# ADDENDUM 001

<b>project</b>	Kearns Oquirrh PFC Improvements	<b>project no</b>	18745.00
<b>date</b>	2019-02-04	<b>no. pages</b>	
<b>owner</b>	Kearns Improvement District		
<b>contractor</b>			
<b>bid date</b>	2019-02-12	<b>bid time</b>	3:00 pm MST

**Electrical Addendum No. 1**

# ADDENDUM

## PARTIAL POWER SINGLE LINE DIAGRAM

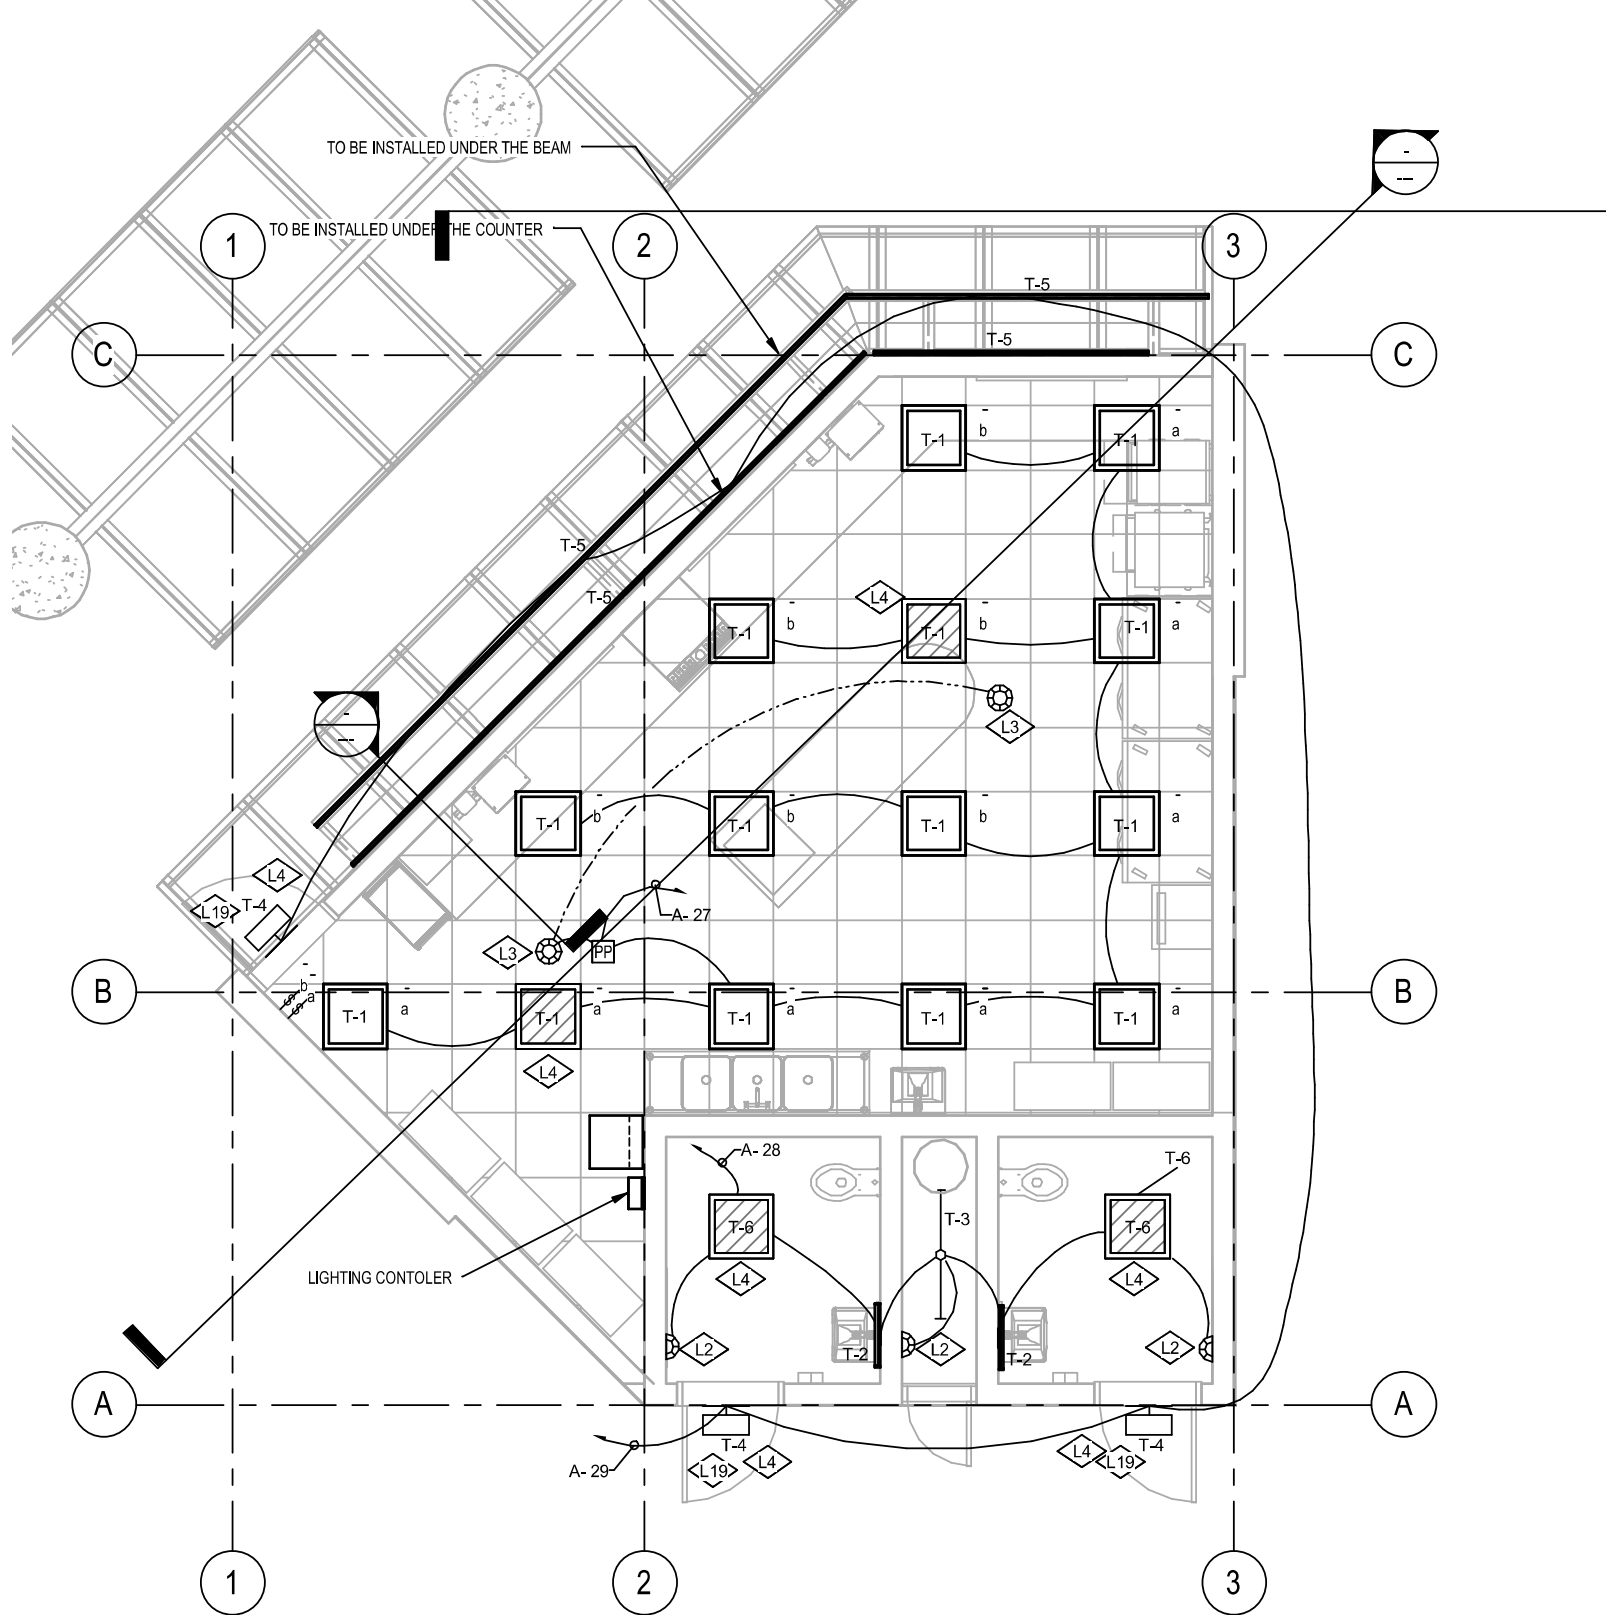
1. Add a circuit breaker type disconnect as shown on the attached revised power single line diagram inside the building to feed the new 45kva transformer, install it on the wall near the main entrance.

**Sheet EP601:**

1. Add the attached revised Power Single Line Diagram.
2. Branch panel "A" shall be provided with NEMA3 type enclosure.
3. In panel "A" all circuits feeding electrical loads in the kitchen shall have ground fault protection at the outlet if not the circuit breaker feeding them shall be provided with ground fault protection including circuit breakers for 208 single phase circuits.

WORKING LIGHT FIXTURE SCHEDULE

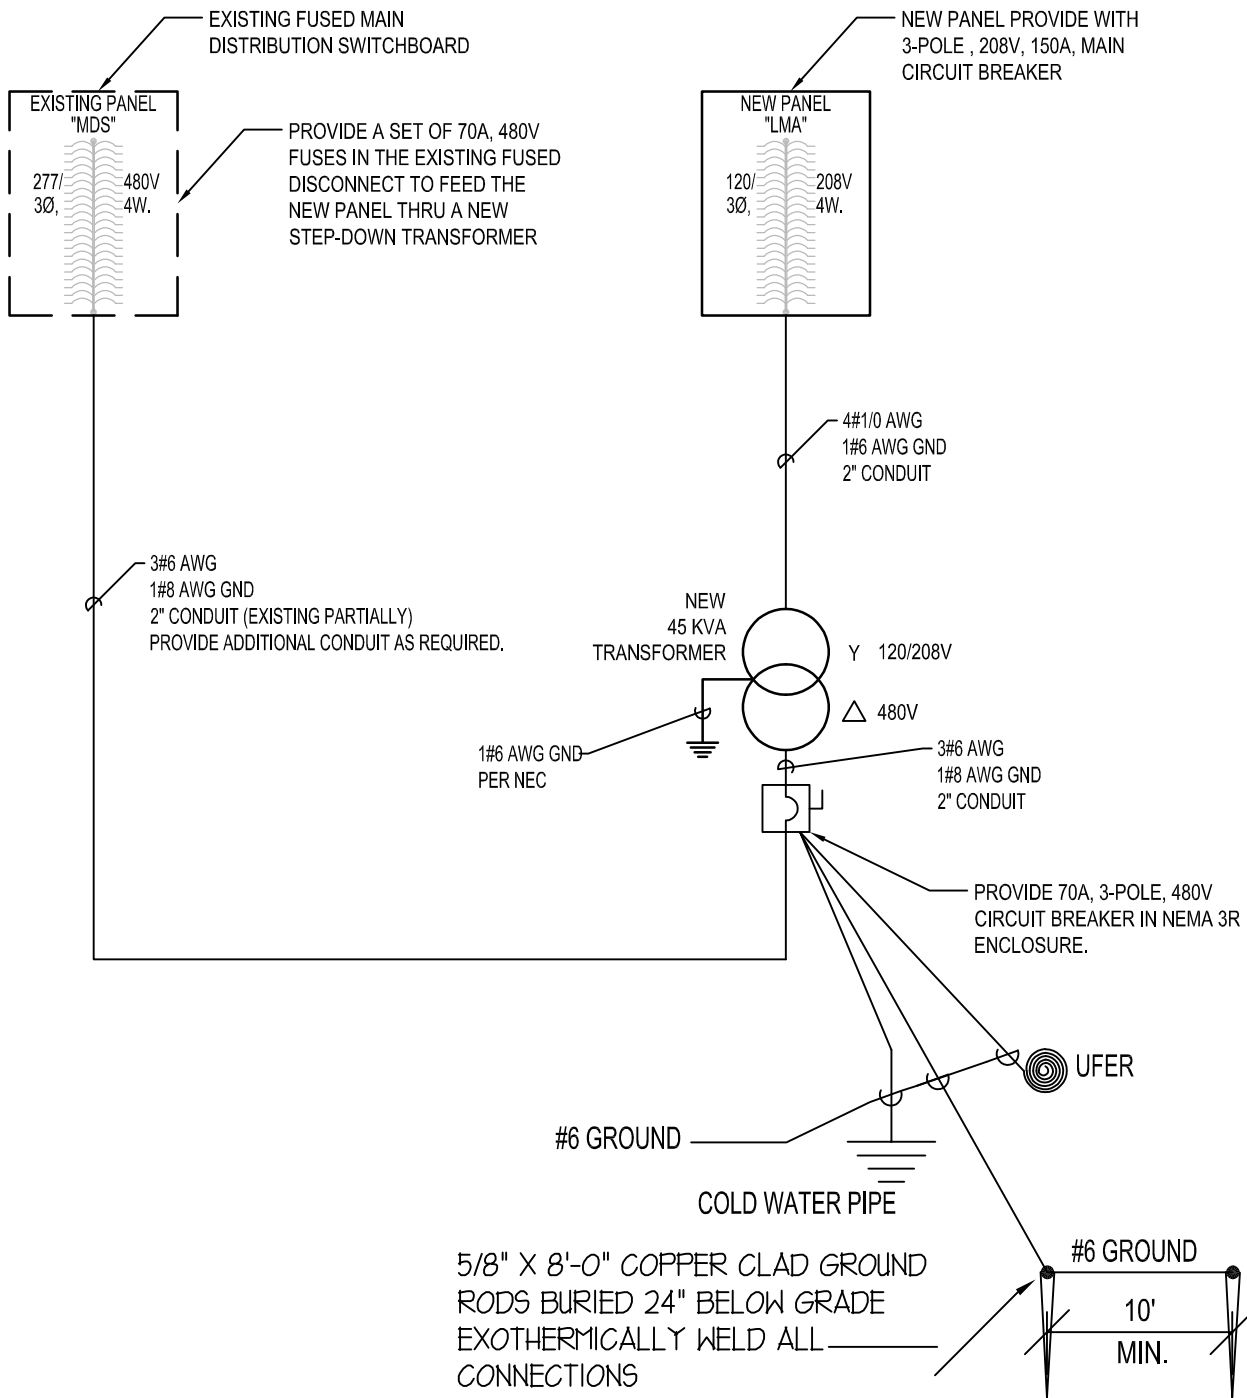
**Sheet EE001:**

1. Add the attached revised light fixture schedule.

**1 MECHANICAL PLAN**  
SCALE: 1/4" = 1'-0"

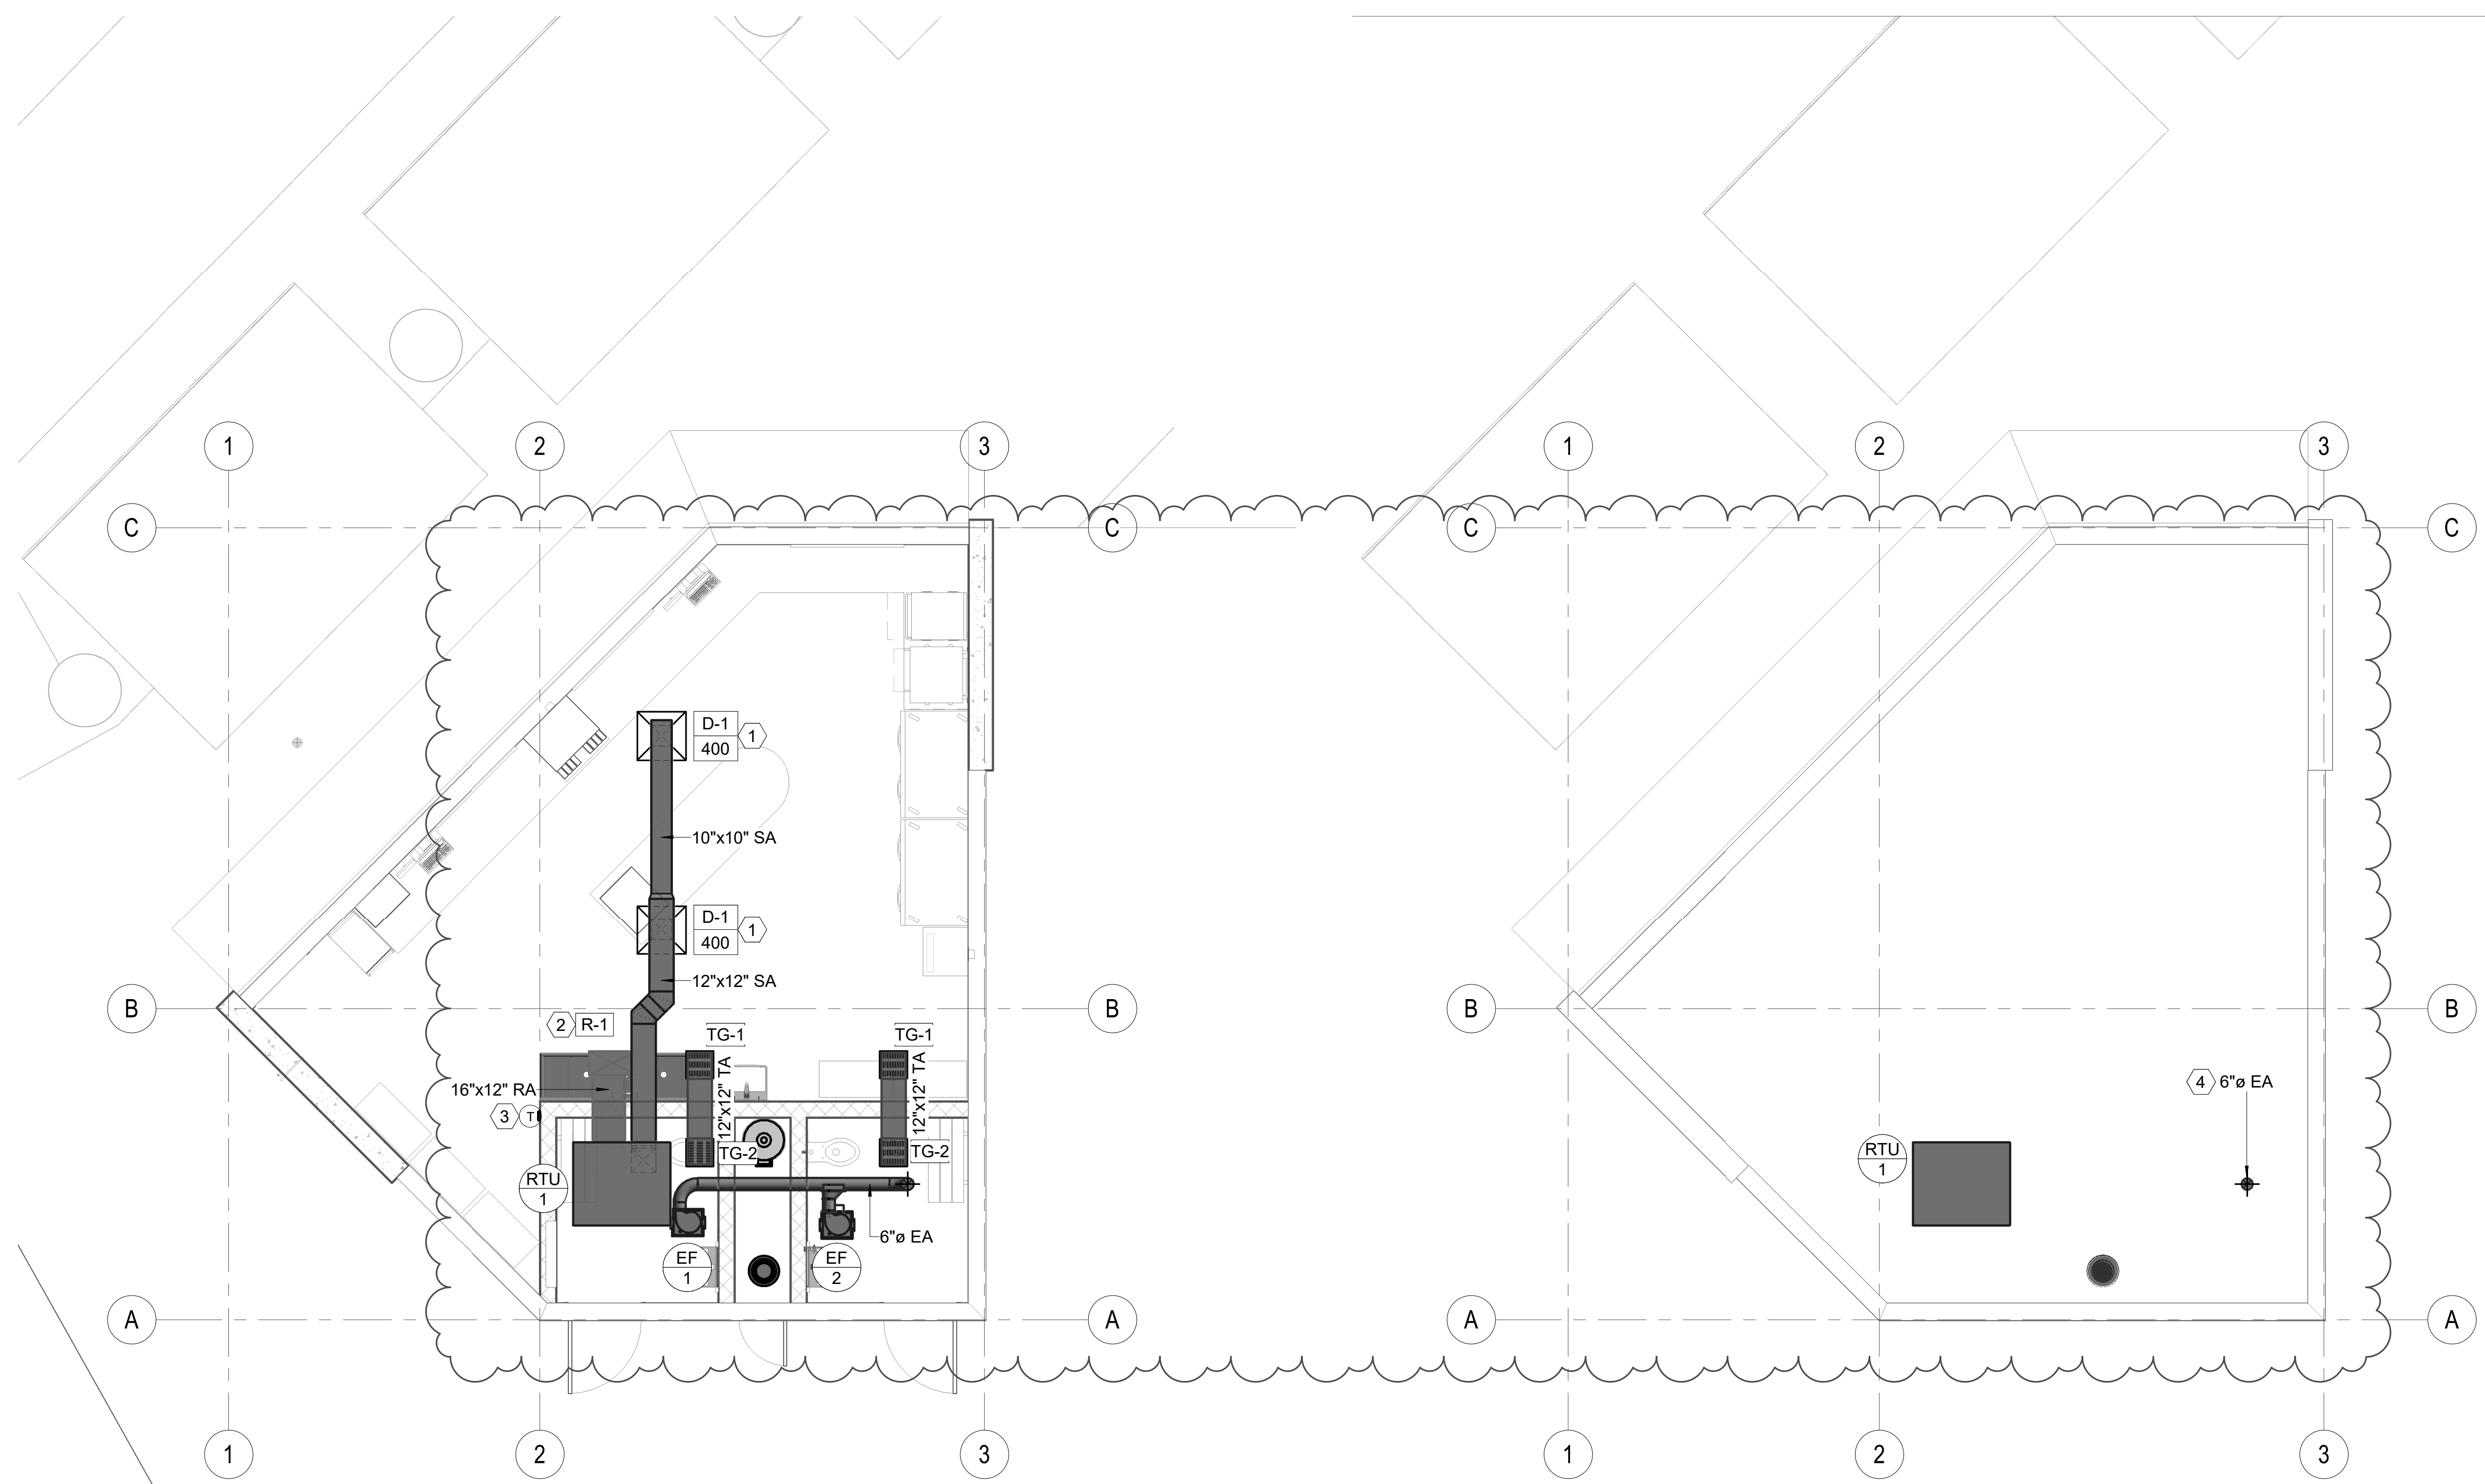
- Item VI-1.** ME101: Duct layout has been redesigned to coordinate with structural. Rooftop unit location shifted slightly and was rotated 90°. Relocated supply diffusers and return grille. Exhaust duct up through roof location shifted slightly.
- Item VI-1.** ME601: Exhaust fan model number change, electrical demands increased slightly. R-1 return grille changed to 24"x12".
